PROPOSED IGA SUPERMARKET

### **SECTION 4.55 (1A) MODIFICATION of**

Development Consent No. 2018/LD-013 Rev 01
Demolition of the existing structures and construction of a supermarket

#### **MODIFICATION STATEMENT**

GROUND FLOOR - FITOUT PLAN

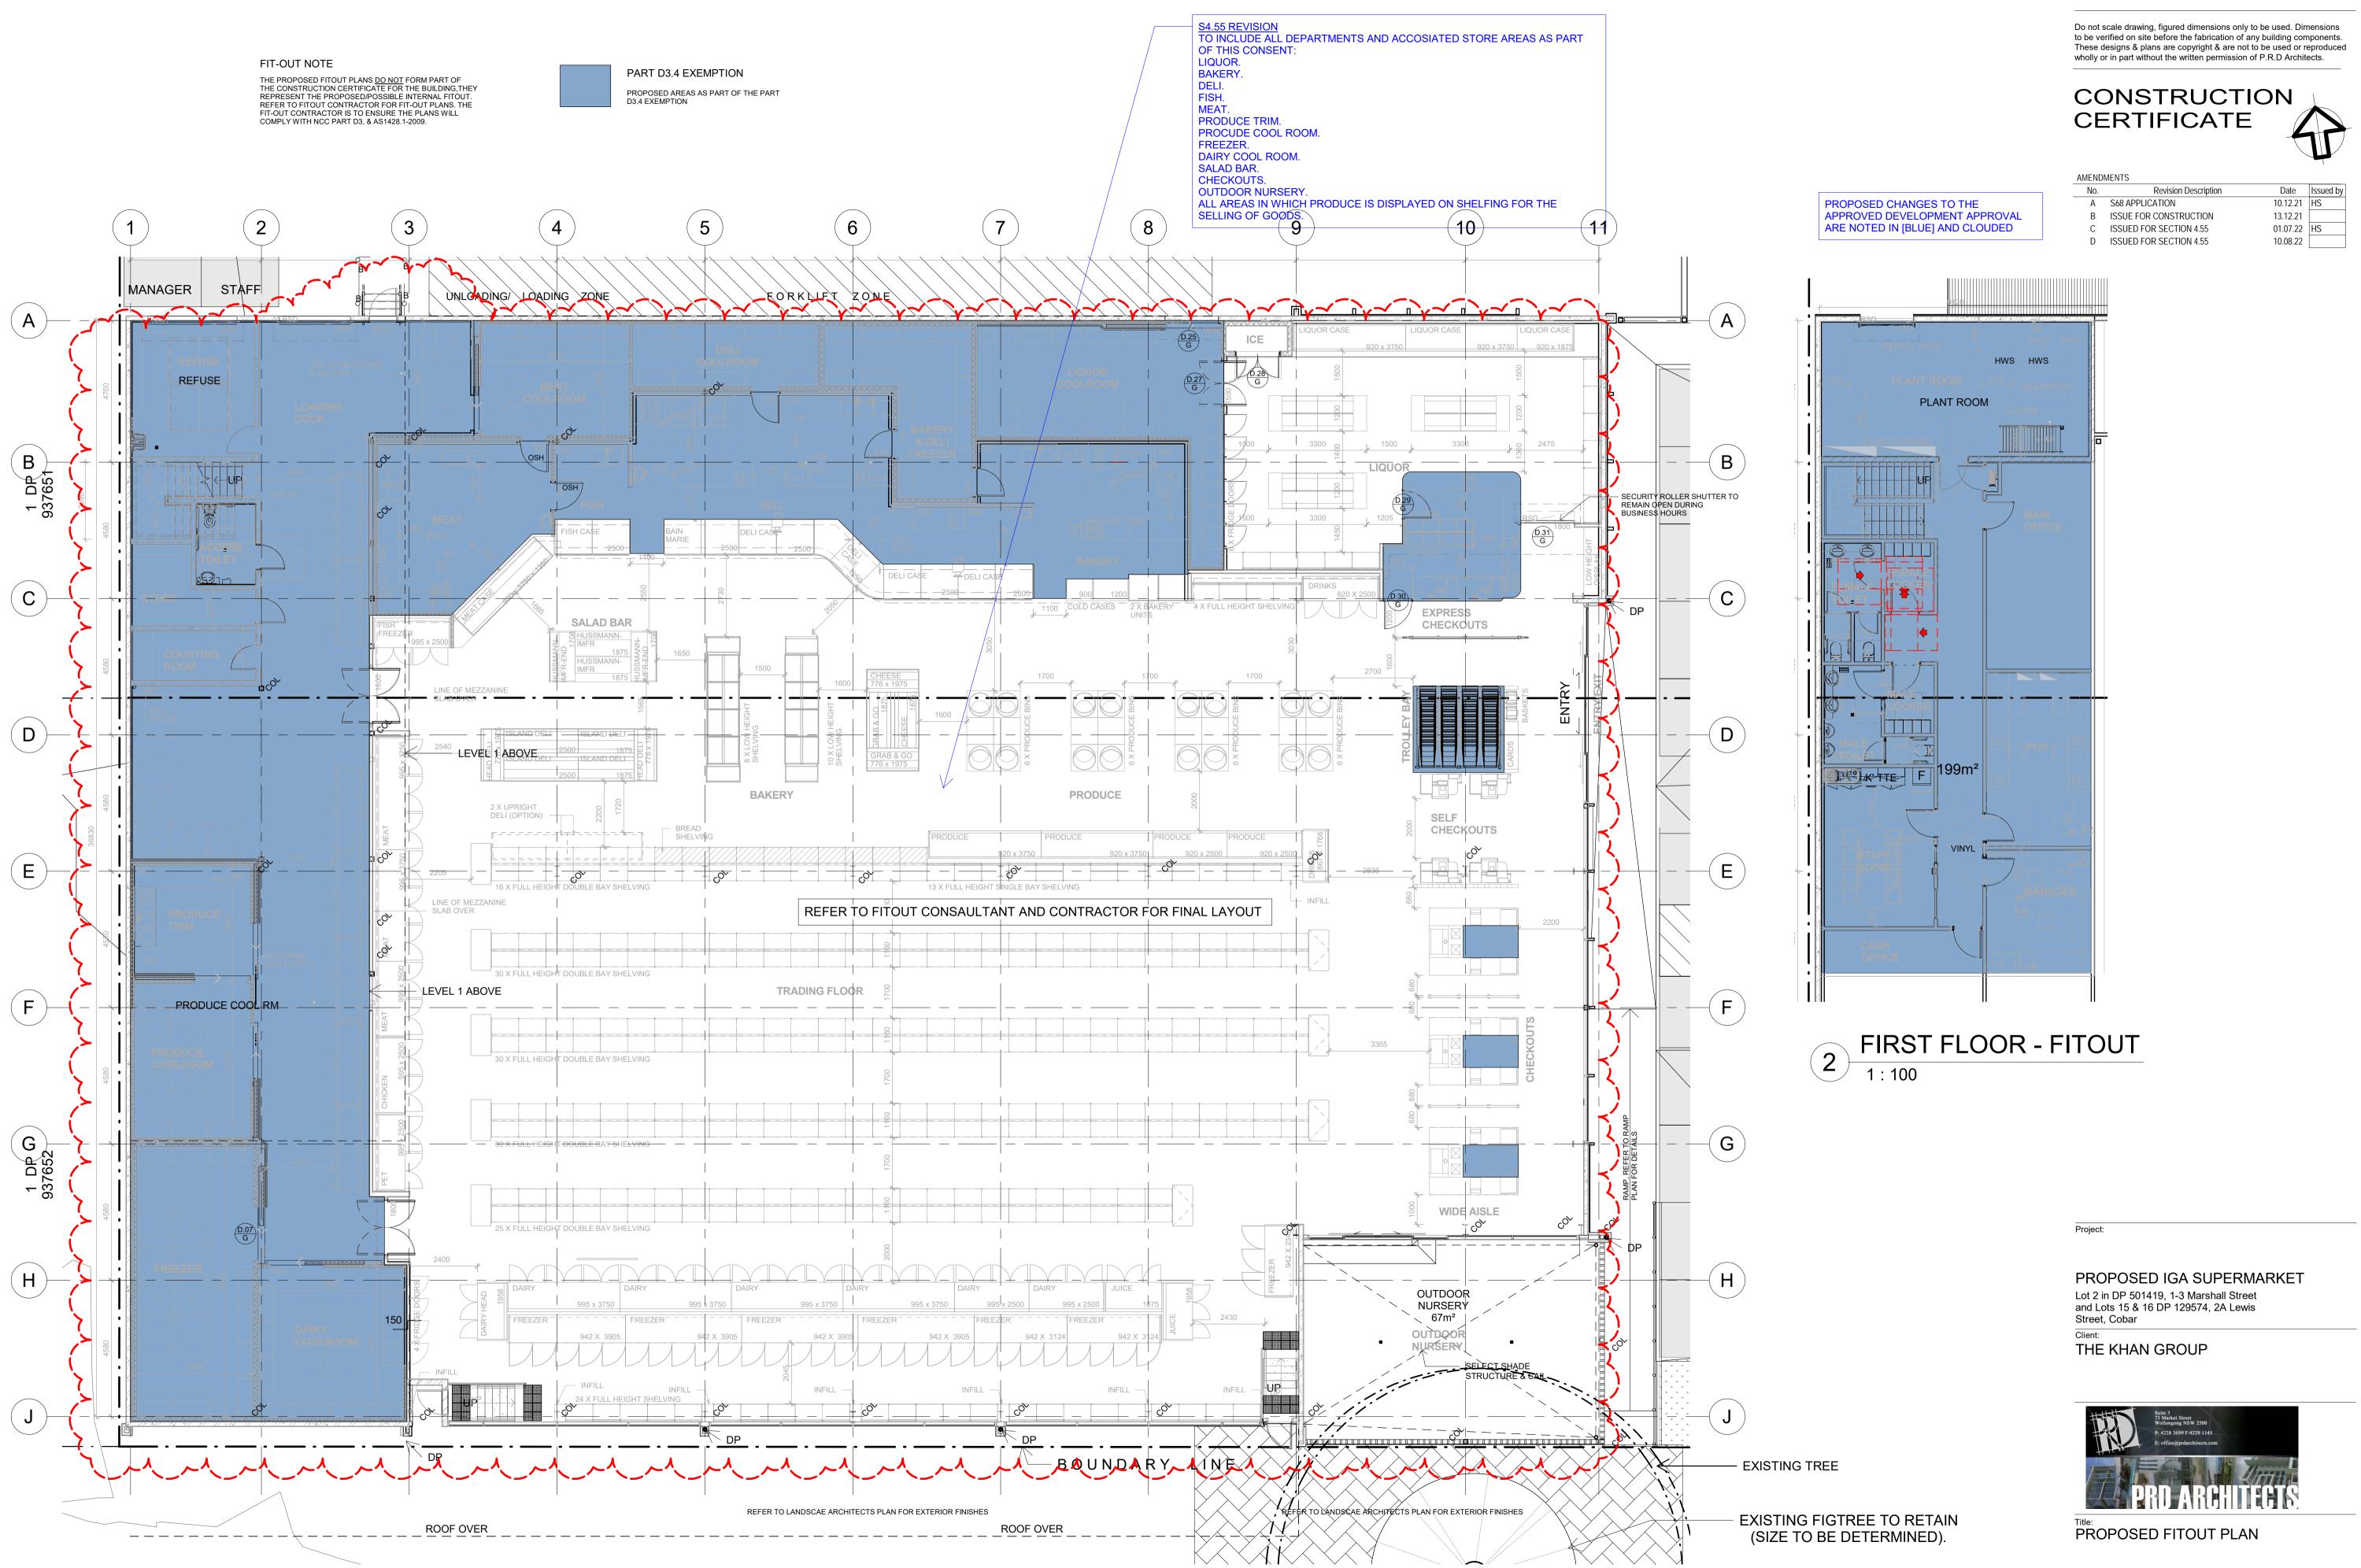
Internal fit-out of any areas within the building, this includes but is not limited to Liquor, bakery, Deli, fish, Meat, Salad Bar, all produce areas on the main floor, Produce trim area, Produce cool room, Freezer, Dairy cool room, outdoor nursery & all offices spaces, shall be obtained from the relevant consent and/or certifying authority for the above works and uses.
